OPTIONAL SERVICE BULLETIN NO. DAC1-33-06 REV. 3

SUPERSEDES DAC1-33-06 REV. 2

I.4 Subject

This service bulletin addresses the replacement of Whelen's anti-collision/position light assembly (A600PG-14/A600PR-14) with the installation of Whelen's LED anti-collision/position light assemblies in the DA 20-C1.

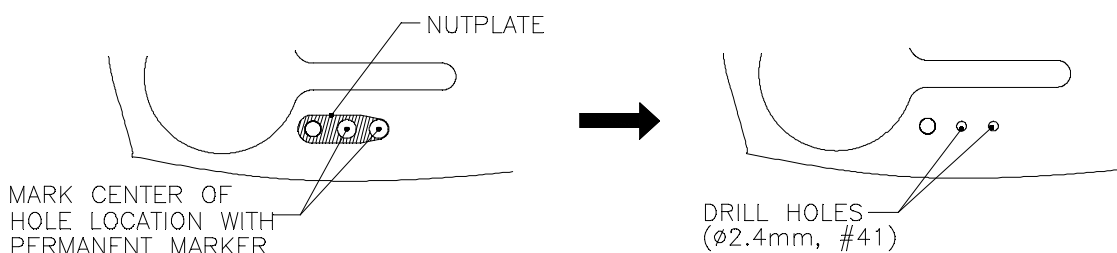
3. Remove the existing left hand and right hand wingtip ACL/Position light assembly per DA20-C1 AMM Chapter 33-40-00.
4. Use the right hand LED bracket (item 5) as a template over the left hand wingtip holes. Mark the rivet locations with a permanent marker, and drill.

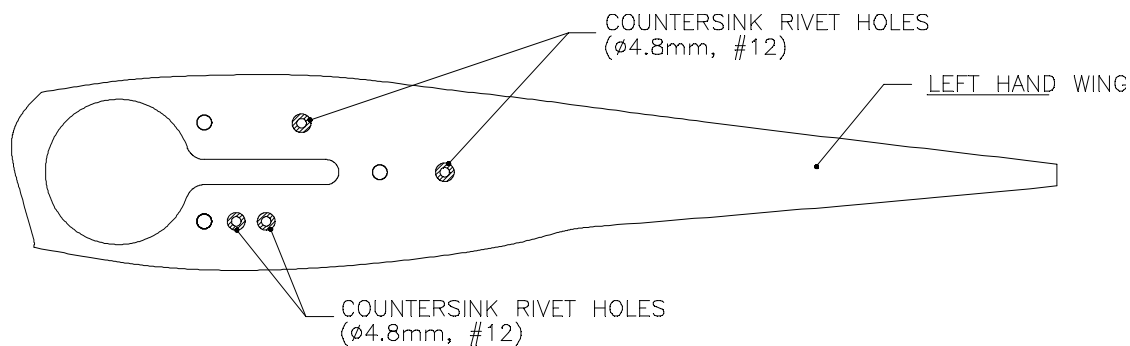
5. Align nut plate (item 12) on left hand wing as shown, and mark the rivet locations with a permanent marker. Remove nut plate, and drill.

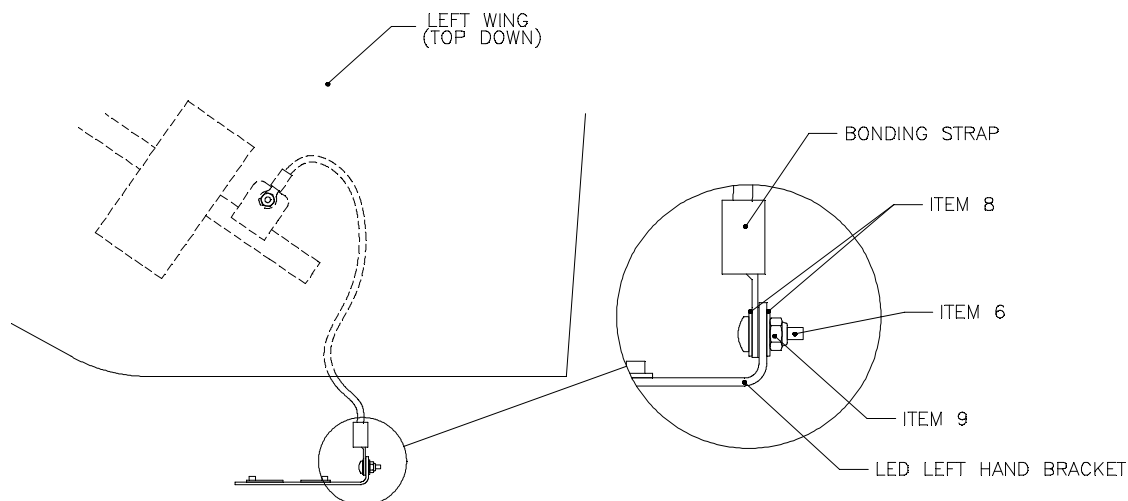
6. Counter sink new rivet holes as shown below.

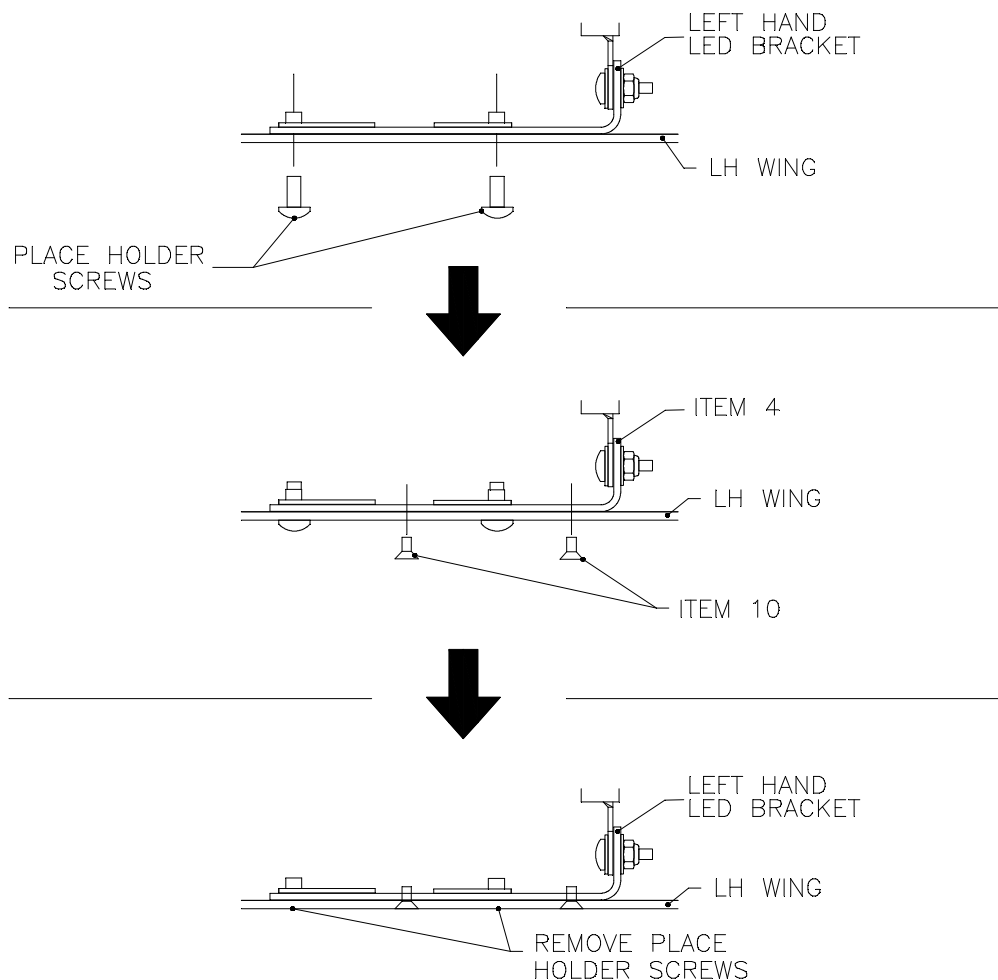
10. Install left hand LED bracket (item 4) inside left hand wing as shown below, and temporarily fasten with place holder screws (item 7). Rivet bracket as shown using item 10, and remove place holder screws.

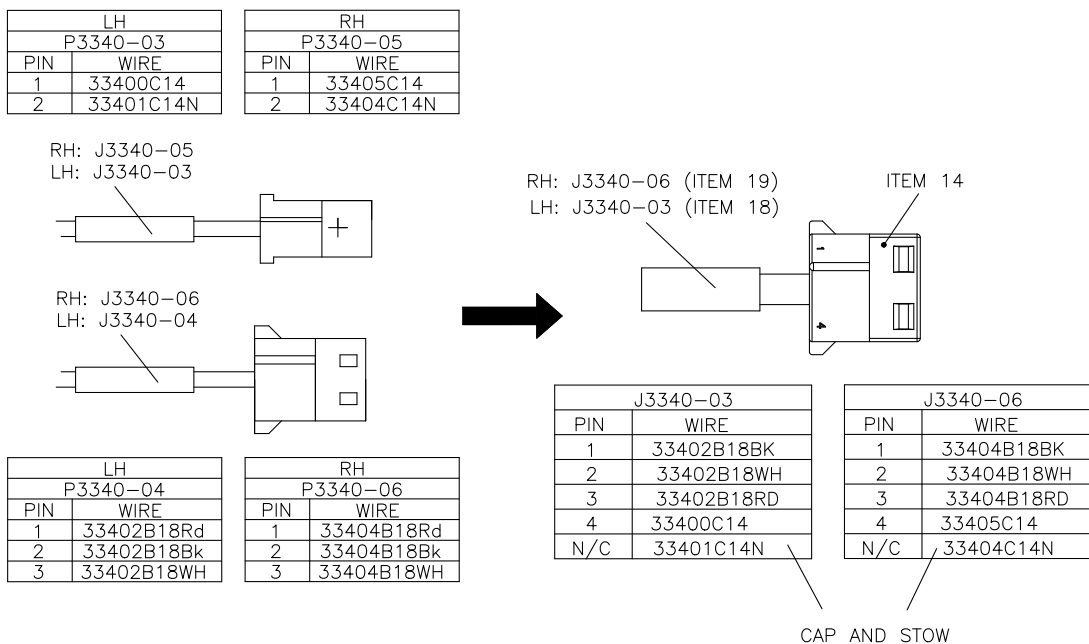
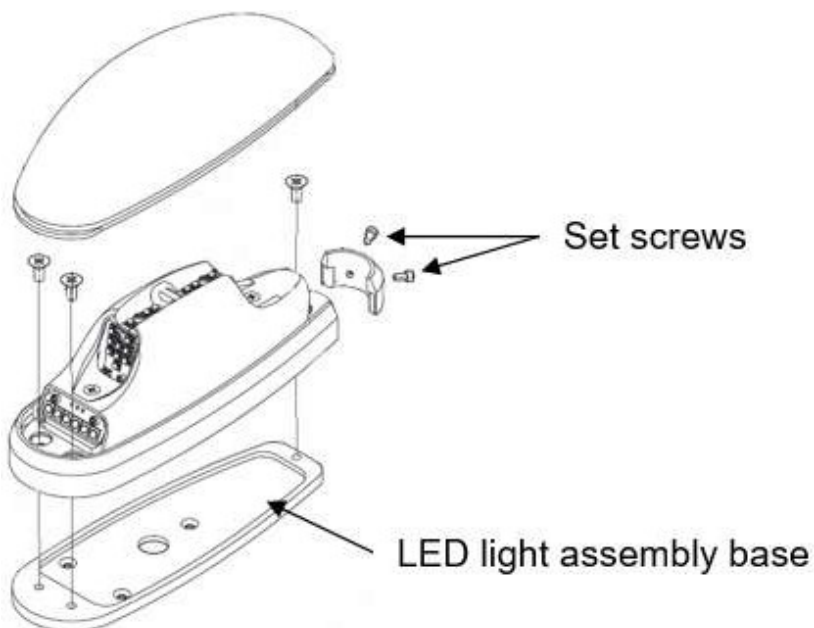
11. Similarly, rivet nut plate (item 12) inside left hand wingtip at location drilled in step 5.
12. Rework left hand ACL/Position light connectors into new single connector (item 14) with new label (LH: item 18; RH: item 19) as shown below. Cap and stow unused ground wire with heat shrink (item 15).

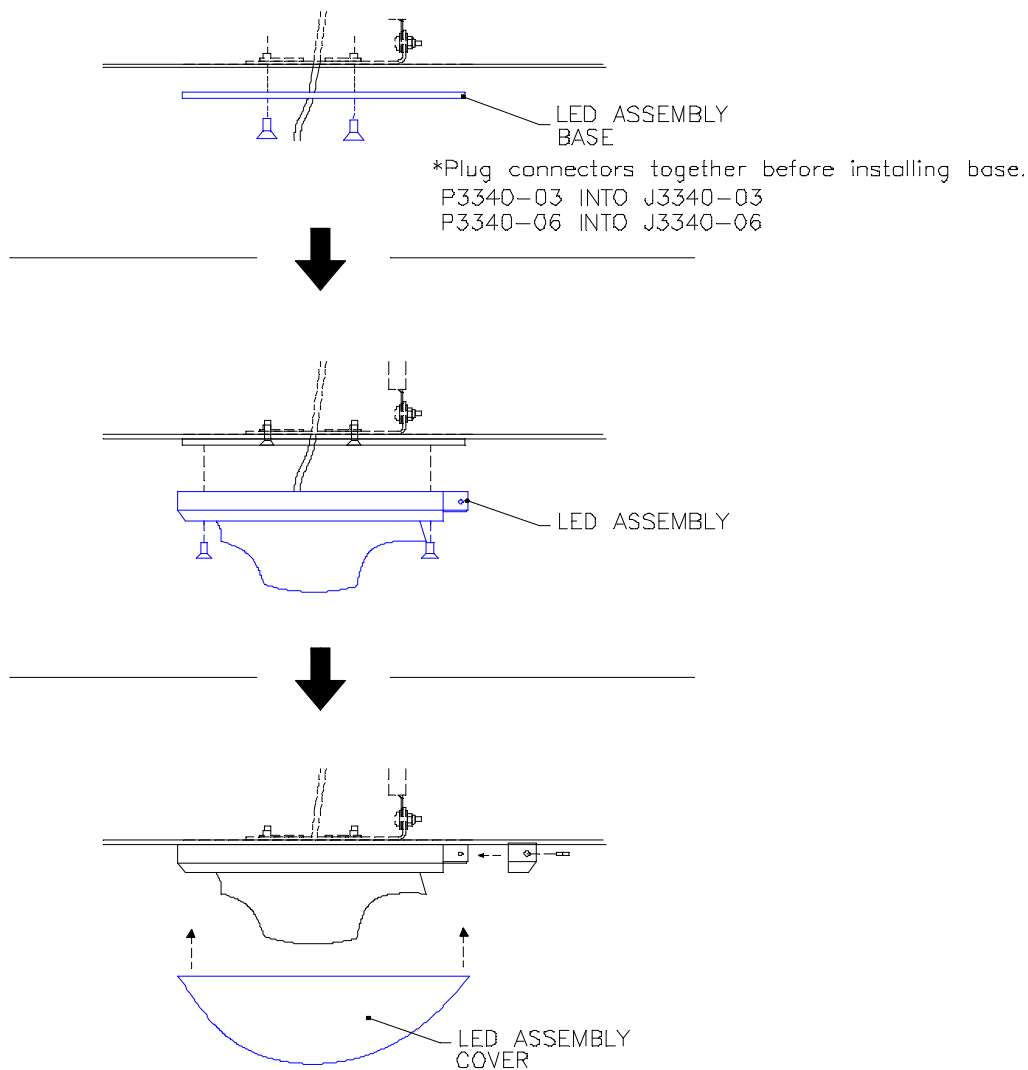
14. Install left hand LED light assembly (item 2) as shown below in the left hand wing.

NOTE: verify prior to installation that the LED light assembly is labeled with “LH.”

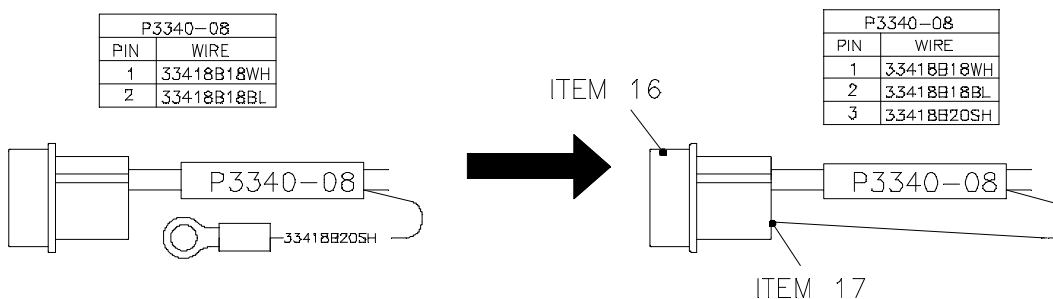
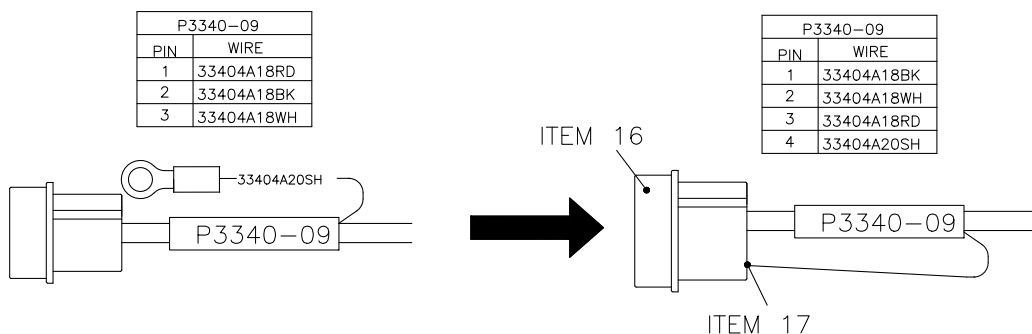
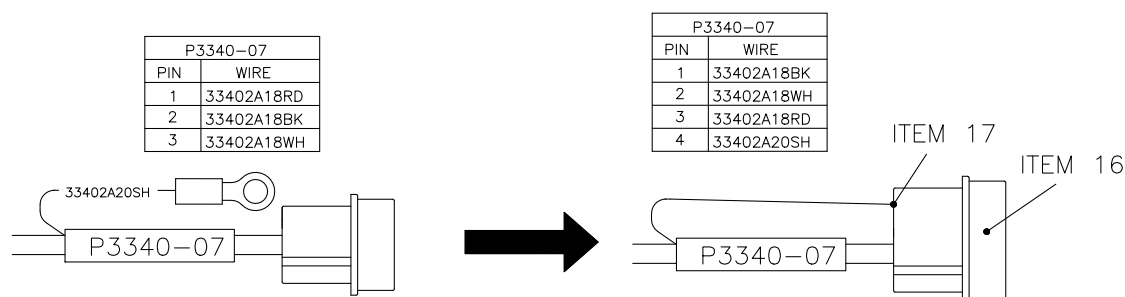
15. Apply fillet of sealant (Marine 4000 or equivalent) around edge of LED light assembly and left hand wing.

NOTE: do not cover light assembly drain hole when applying sealant.
